**HESTVATN HYDRO-ELECTRIC PROJECT**

**PROJECT REVIEW**

**THE STATE ELECTRICITY AUTHORITY  
NOVEMBER 1961**

**SUMMARY LETTER**

THE STATE ELECTRICITY AUTHORITY ICELAND	
HESTVATN PROJECT	
ESTIMATED COST OF ENERGY	
HARZA ENGINEERING COMPANY APPROVED. <i>C. J. W. Kelly</i>	
CHICAGO, ILLINOIS	DATE Oct 1961
	DWG NO 279 P2

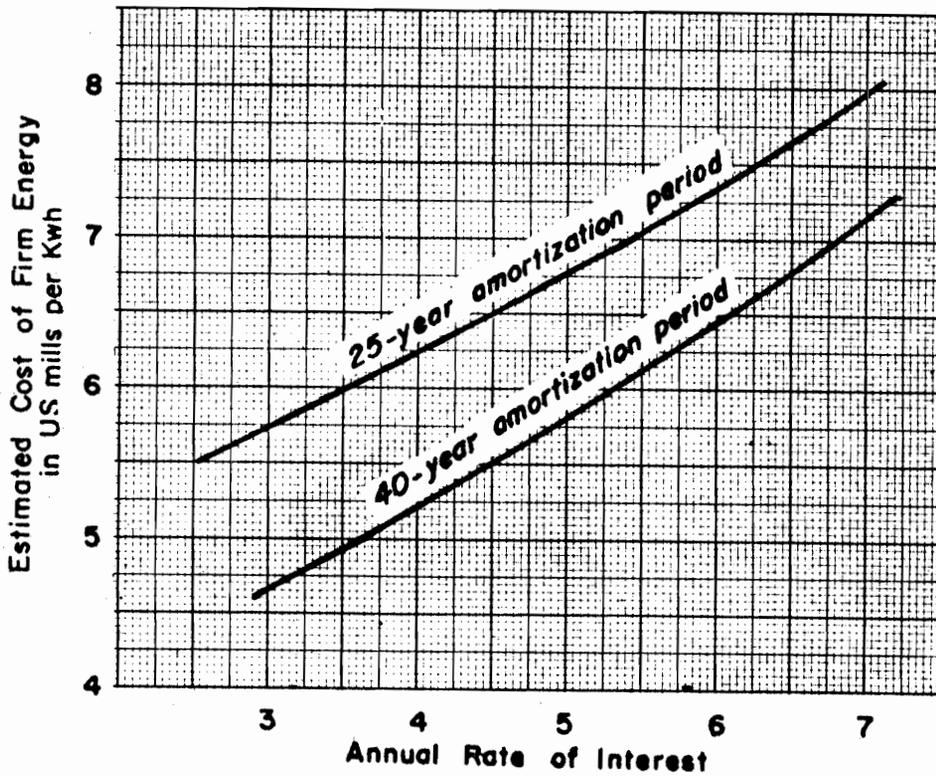
The unit cost of energy is arrived at simply by dividing the annual charges with the amount of firm energy produced in a year. If we, as previously discussed, assume that 200 million kilowatt hours would be produced and delivered to the power system annually the cost of energy will be as shown graphically on Exhibit 2.

The curves show the cost of energy delivered on the low tension side at Ellidaar for interest rates ranging from three to seven percent and for amortization periods of 25 and 40 years. Taxes that may be levied on the operation of the power plant are not included in the estimated unit cost of energy.

For most common financing terms, the cost of firm energy will be between five and seven mills (U.S.) per kilowatthour. With an interest rate of five percent and 40 years amortization, the cost will be about six mills per kilowatthour. If the project could be exempt from import duties and taxes, the cost of energy would be reduced by about one mill. The value of the secondary energy that may be produced can not be predicted with any reasonable certainty at this time. We estimate that the crediting of income from the sale of secondary energy to the annual costs would result in decreasing the estimated unit cost of primary energy by two-tenths of one mill for each mill per kilowatthour received from the sale of secondary energy.

**DIVERSION DAM**

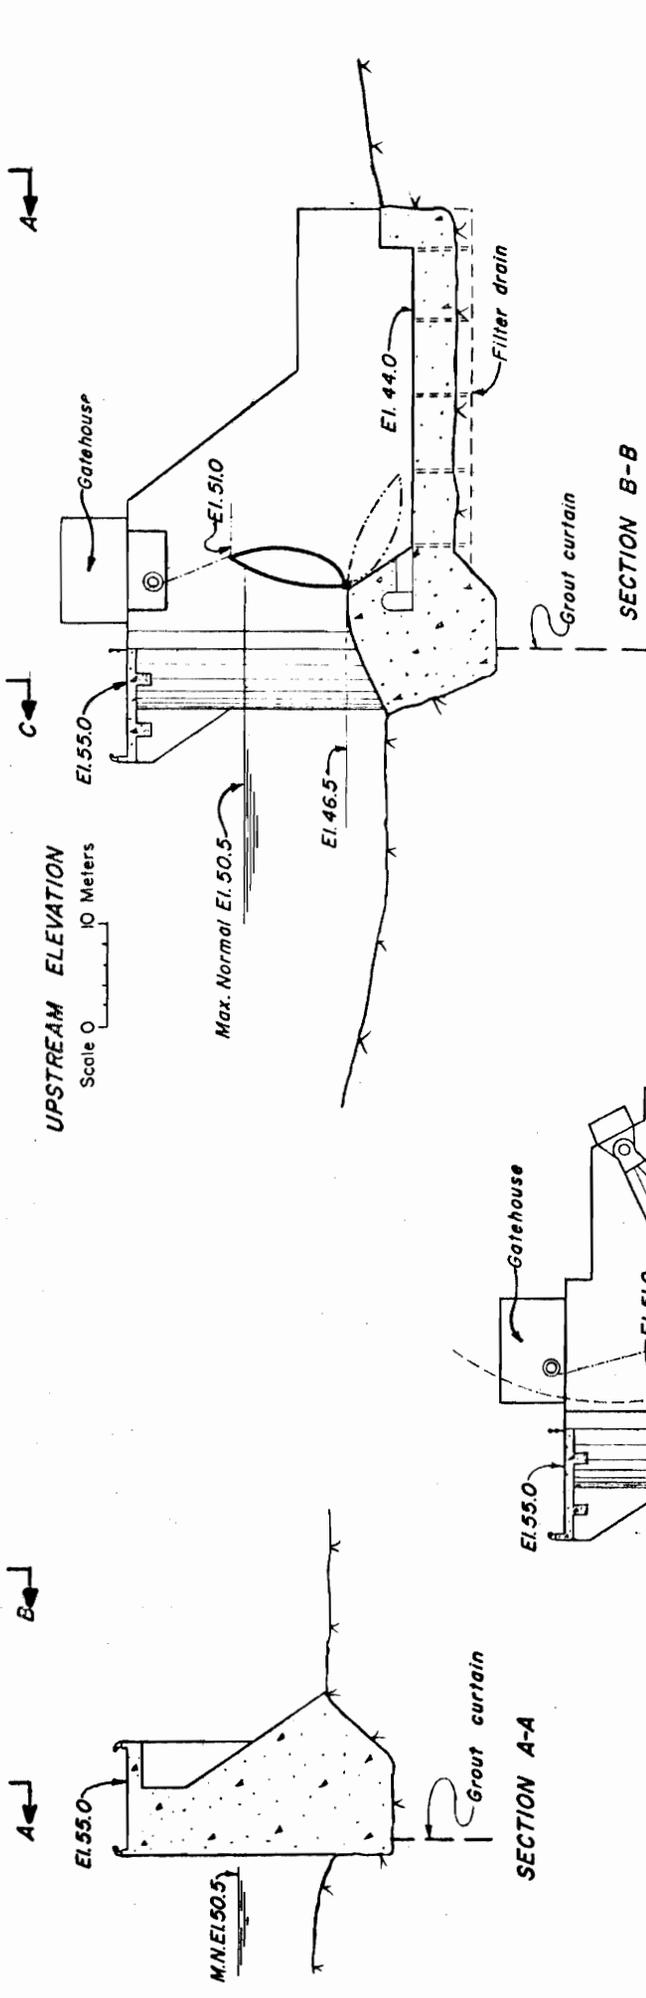
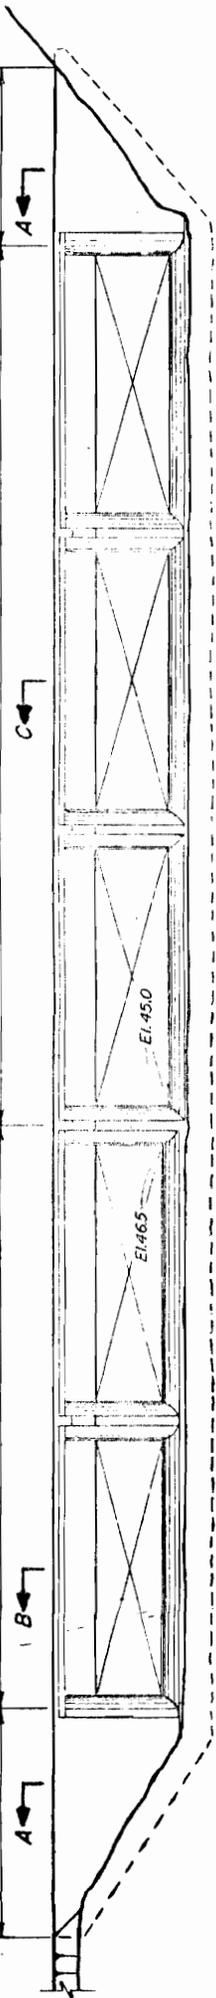
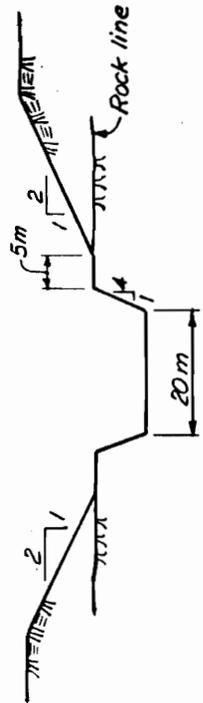
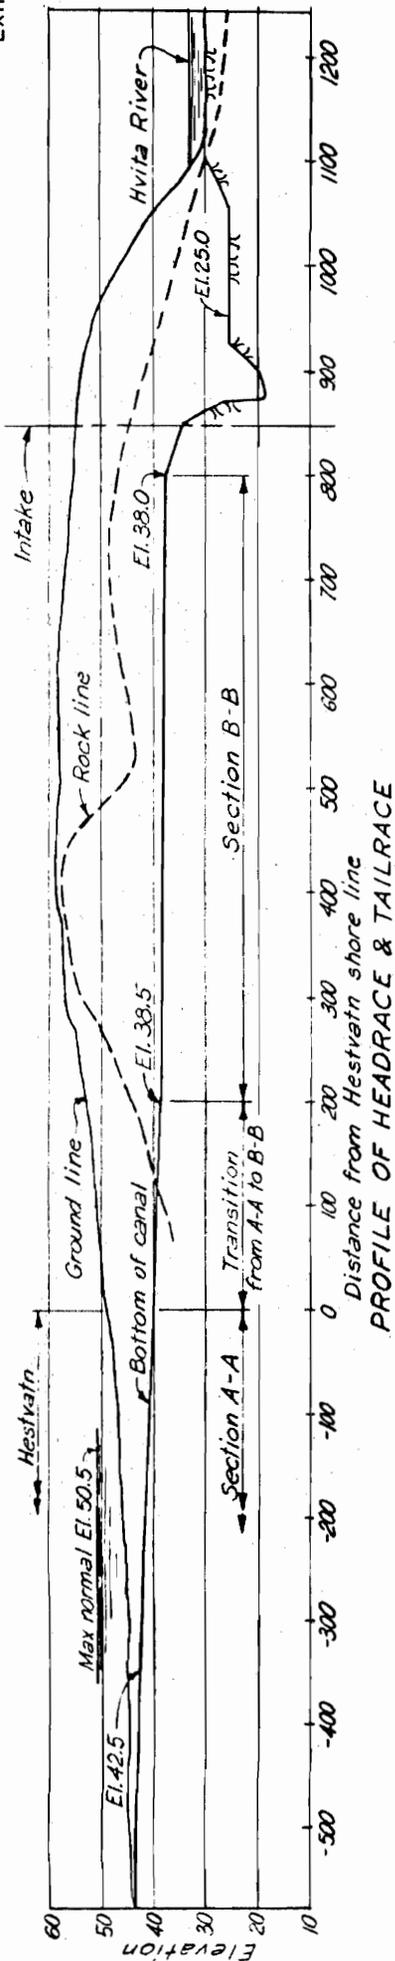
Diversion Dam. Our suggested design for this structure is little different from the one shown by Thoroddsen on drawing 5-2.1.01 and designated "First Dam Alternative." Twenty-five meter openings between the piers should be adequate for passing sheet ice that may accumulate in front of the dam.

There appears to be no reason for using roller gates instead of tainter gates as the latter are less expensive and would probably be more reliable in operation. We agree that at least two of the five bays should be provided with gates that can be lowered to permit the passing of floating ice without excessive use of water. The fishbelly flap gates proposed are well suited for this purpose and would probably not cost more than the tainter gates. In fact, the overall cost may be less because the piers would be smaller. There may, however, be some problems associated with operation of the flap gates as a result of formation of ice downstream of the gate and for this reason we do not recommend that all openings be provided with this type of gate. Some heating of the pit into which the flap gate is lowered may be necessary as well as heating of all gate guides and seals.

The structural design of the spillway as shown in the Project Plan Report is considered to be conservative. A design as shown on Exhibit 3 is considered satisfactory and will result in considerable savings in excavation and concrete. The total volume of concrete is estimated at 13,000 cubic meters as compared with Thoroddsen's estimate of 22,500 cubic meters. The top of the dam is at elevation 55.0 which should be entirely safe considering that the terrain on the left bank is at elevation 52.0 or lower. The spillway crest is at elevation 45.0 for the tainter gates and at elevation 46.5 for the flap gates, or slightly below the present level of the riverbed. The openings will have an area of 625 square meters to elevation 51.0 as compared to about 710 square meters for the natural section. Hydraulic model studies will be essential in final design, in order to verify the hydraulic adequacy.

The foundations for the dam should present no serious problems. Both the Thjorsa lava and the palagonite tuff and breccia that underlie the damsite will easily support the low structures contemplated. The contact between the tuff and the lava may contain talus and will require careful grouting in order to reduce seepage to permissible limits. Nominal curtain grouting will be required elsewhere and should extend about 50 meters beyond the left abutment of the dam. A grouting gallery underneath the dam is not proposed.

It is our opinion that a fish ladder will be required on both sides of the spillway as the fish may not be able to find the entrance to the ladder on the opposite side when the spillway is operating. The downstream entrance to the ladder should be located close to the spillway whereas the exit into the headwaters should be brought to a point upstream where the flow velocities would be sufficiently low as not to carry the fish back through the weir. The total length of each ladder would, however, be approximately as shown in the Project Plan Report. It is probable that the hydraulic conditions at the fishladder exit would be improved by placing a tainter gate at each end of the spillway rather than all three on one side, because tainter gates would give lower surface velocities under partial gate openings.

HEADRACE AND TAILRACE  
PROFILES AND SECTIONS

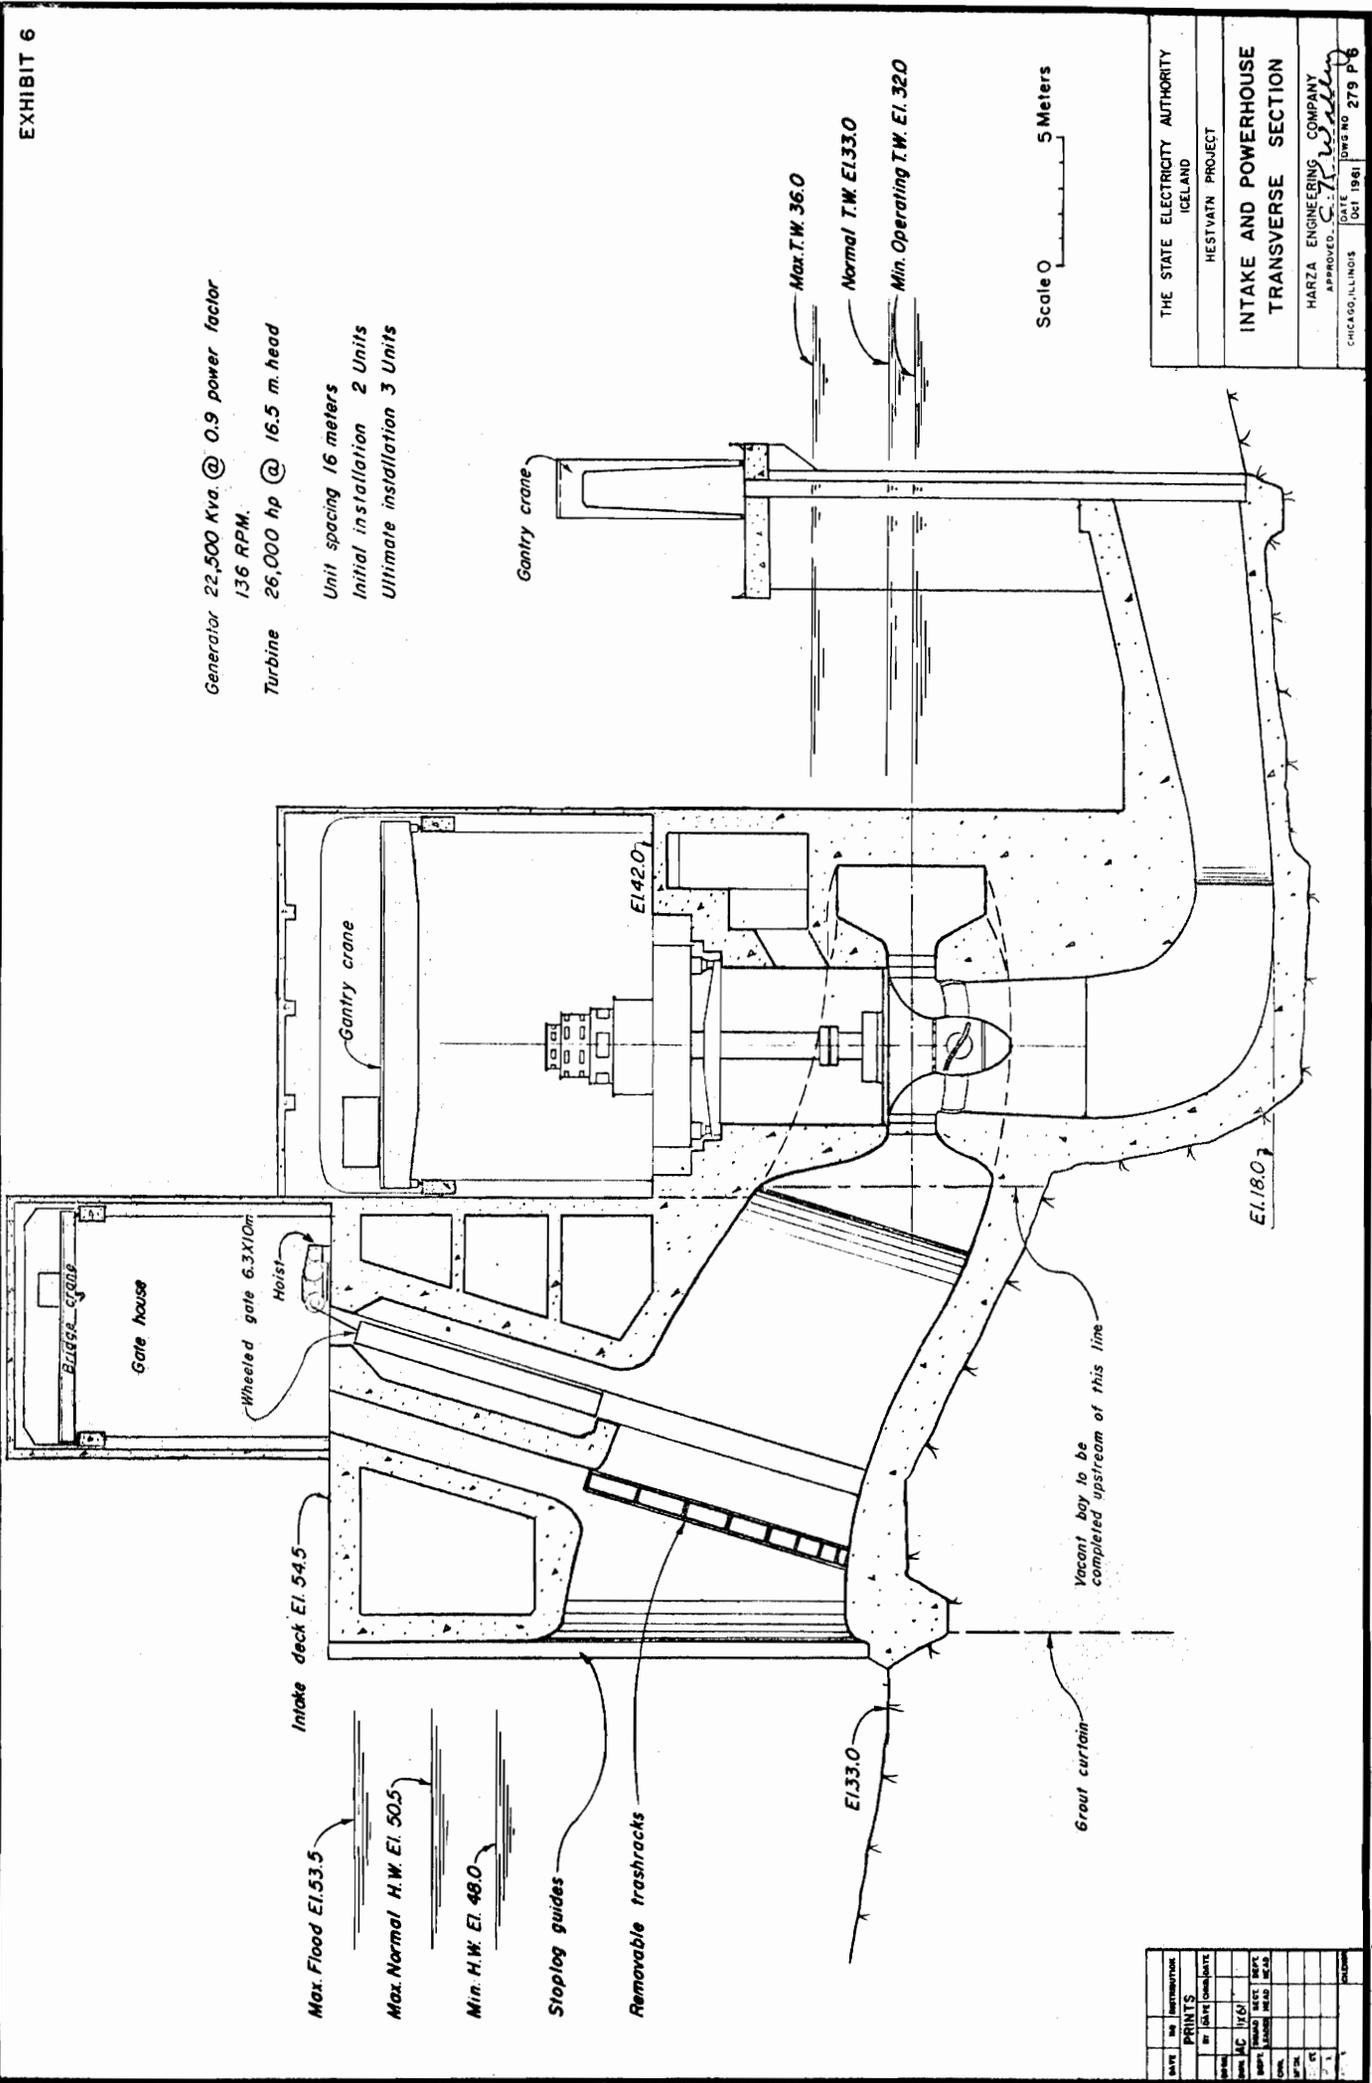
Headrace Canal. We have no comments to make to the design of the headrace canal as presented in the Project Plan Report, except that the bottom of the canal could be raised about one meter as a result of the higher headwater levels proposed by us. A profile and sections of the canal for reservoir elevation 50.5 is shown on Exhibit 5. For the maximum flow of 390 kiloliters per second the velocity will be about 0.5 meter per second where the canal section is excavated entirely in soil. This occurs at the entrance near the shoreline of Hestvatn. The velocity will be about 1.5 meters per second where the hydraulic section of the canal is entirely in rock. The portion of the canal that will be in both materials, including a transition section at the entrance, will have velocities between 0.5 and 1.5 meters per second. The average total headloss in the canal is estimated at about 0.3 meters for a flow of 390 kiloliters per second and at 0.15 meters for a flow of 260 kiloliters per second. The most economical cross-section of the headrace channel should be determined eventually on the basis of an economic analysis which would compare the total value of the hydraulic losses and the annual costs for several alternative sections. The total excavation in the headrace canal is estimated at 400,000 cubic meters in soil and 195,000 cubic meters in rock. Dredging in Hestvatn will amount to an additional 120,000 cubic meters.

We propose to make the tailrace channel slightly shallower but wider than shown in the Project Plan Report. We believe that this will improve the hydraulic efficiency on the basis of natural tailwater conditions and would also be more convenient from the construction viewpoint, thus less costly.
